Item ID: D212-664-101TRN

Item Name: Crosstube Turning Detail

DRAWING NO. D212-664-141	TITLE XTUBE ASSY (205/212/412 HI FWD)	REV. D	DART AEROSPACE LTD ENGINEERING ORDER		D.E.O. NO. D212-664-141-D-1	SHEET NO. SHEET 1 OF 2	SCALE NTS
DRAWN	CHECKED	OP	MFG. APPR.	APPROVED	NA	DE APPR.	
DATE 11.04.07	DATE 11.07.11		DATE 11.04.12	DATE 11/04/12		DATE 11.04.12

ADD AN INSPECTION WINDOW TO UNDERSIDE OF CROSSTUBE.

**D212-664-141/-141B
ASSEMBLY DETAIL**

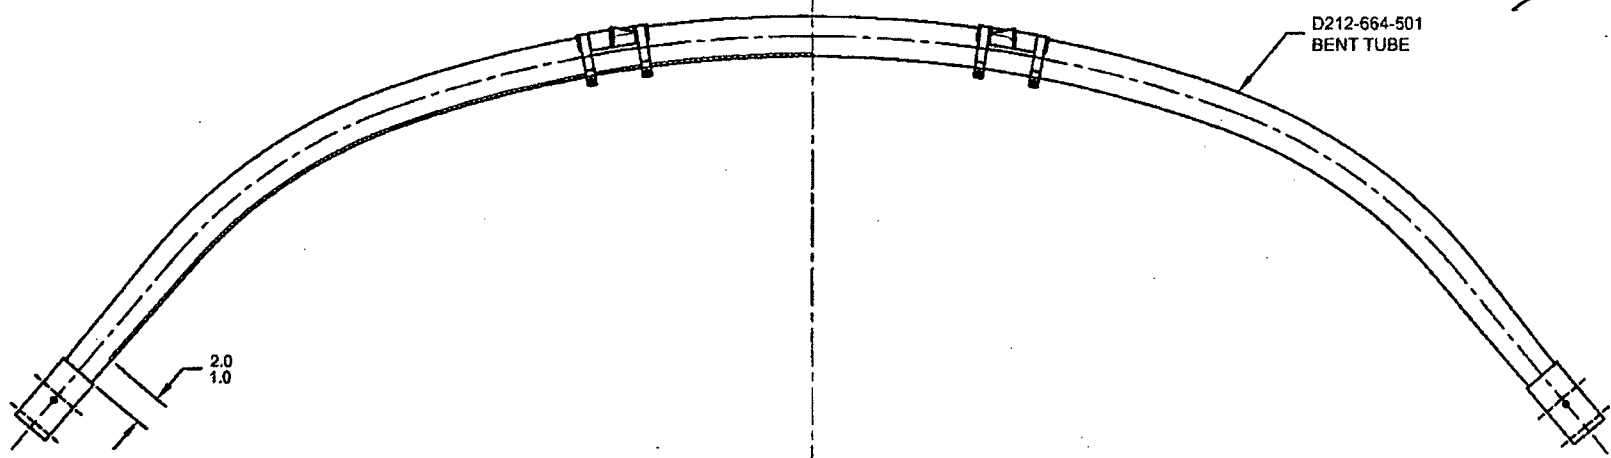
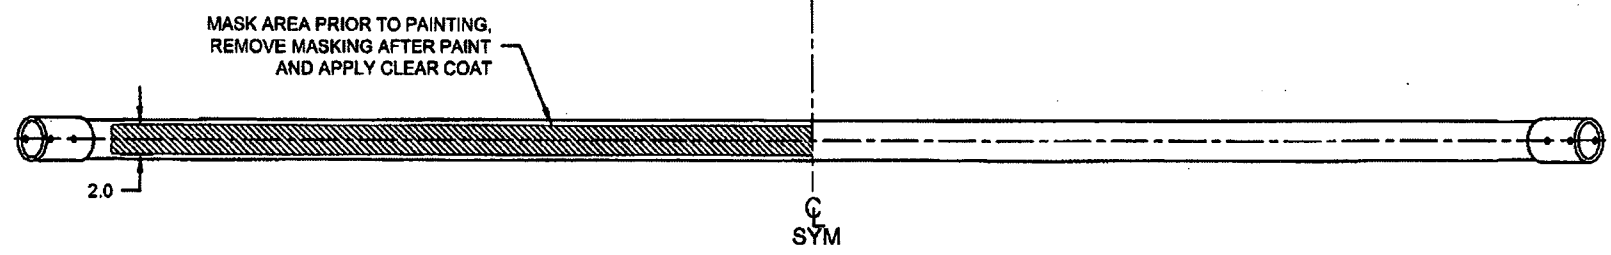
NOTES 2 OF SHEET 1 IS AMENDED AS FOLLOWS:

- 2) FINISH: CHEMICAL CONVERSION COAT PER DART QSI 005 4.1
PRIME INSIDE AND OUTSIDE PER DART QSI 005 4.2
MASK UNDERSIDE OF CROSSTUBE AS SHOWN (HATCHED AREA) AND
PAINT OUTSIDE PER DART QSI 005 4.2
REMOVE MASKING AND APPLY CLEAR COAT

- 2) FINISH: CHEMICAL CONVERSION COAT PER DART QSI 005 4.1
PRIME INSIDE AND OUTSIDE PER DART QSI 005 4.2
PAINT OUTSIDE PER DART QSI 005 4.2
